UNITED STATES OF AMERICA
NUCLEAR REGULATORY COMMISSION

PEER REVIEW MEETING

BMI-2104 REPORT (DRAFT)
RADIONUCLIDE RELEASE UNDER LWR
SPECIFIC ACCIDENT CONDITIONS

VOLUME II: A BWR ANALYSIS

FIGURE 7.3. PARTICLE SIZE DISTRIBUTION OF AEROSOL SUSPENDED IN THE DRYWELL, AE

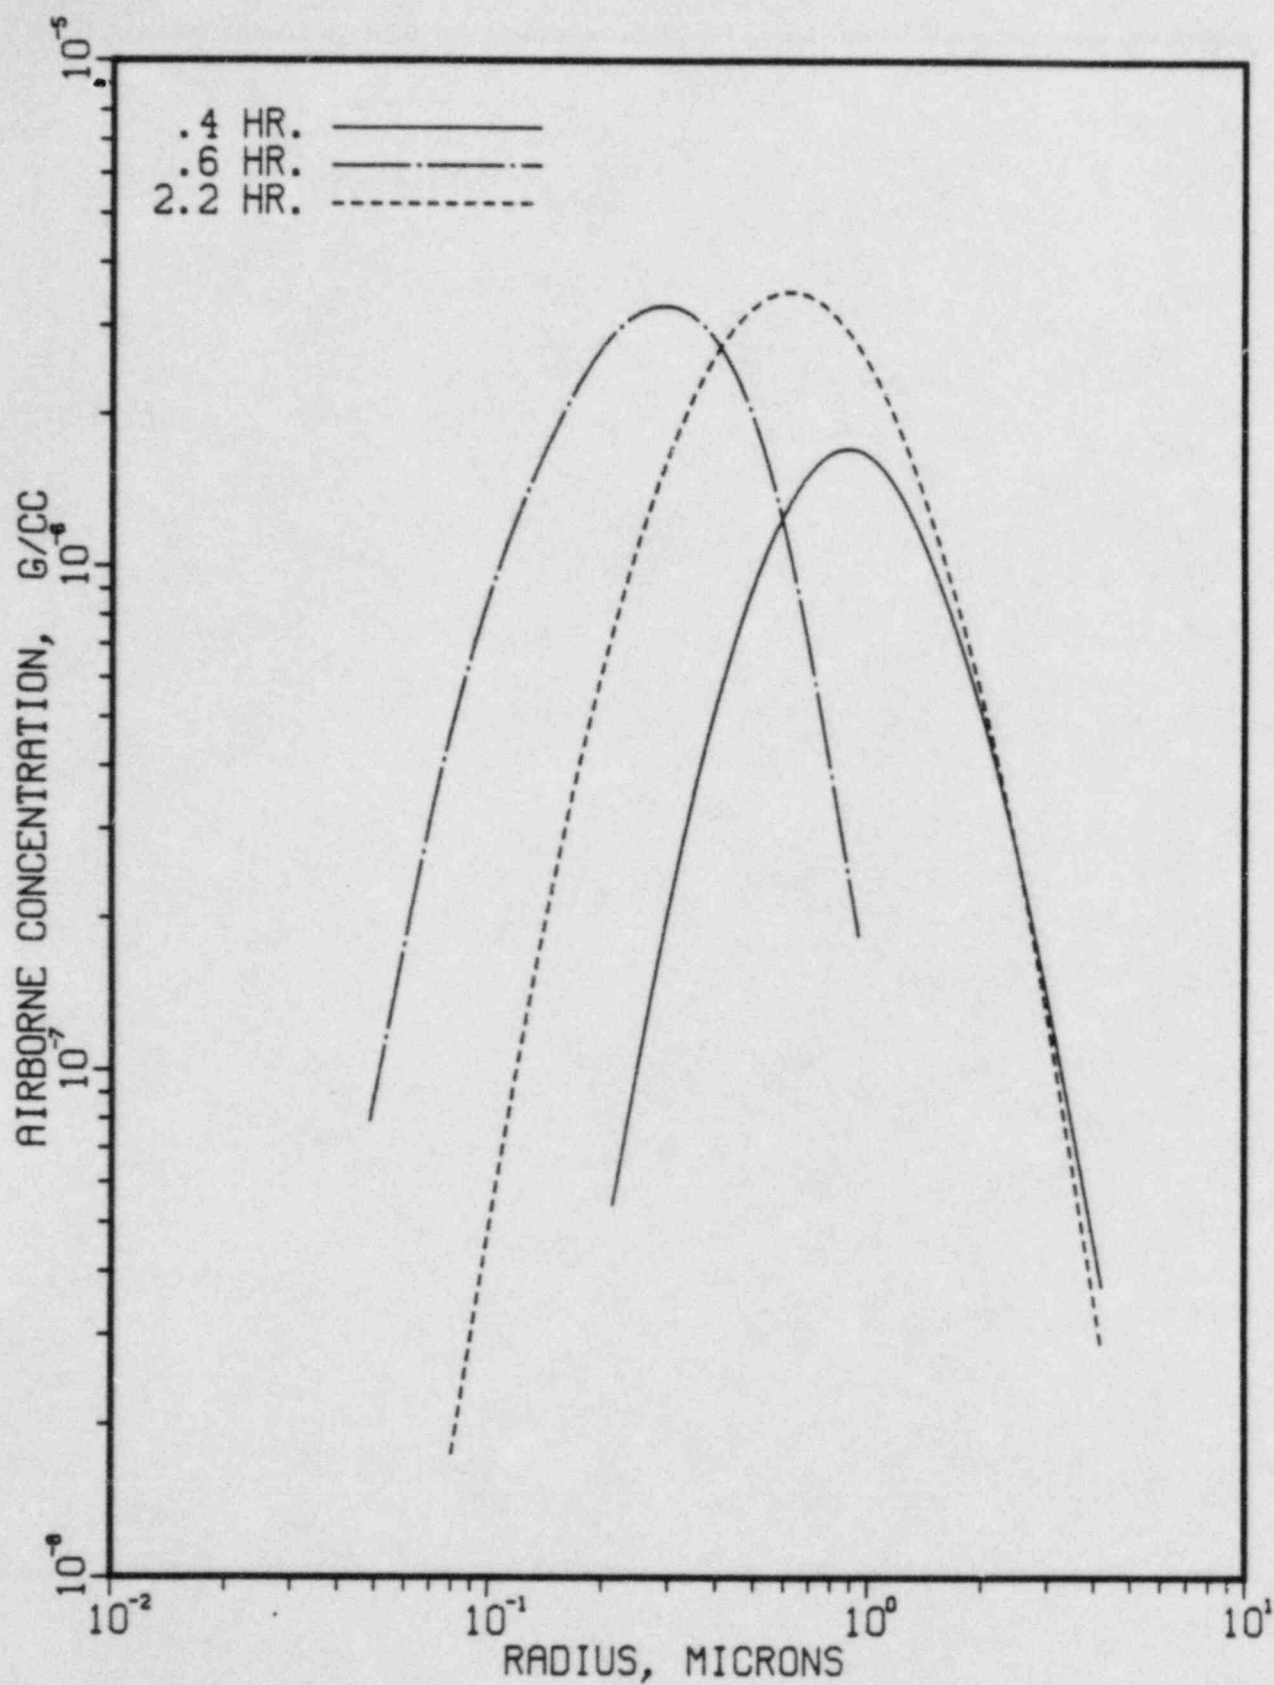
4 On Figure 73, the particle size distribution of
5 aerosols suspended in the dry well, this is probably -- maybe
6 early data. You know the figure I have in mind, it's two
7 parabolic curves.
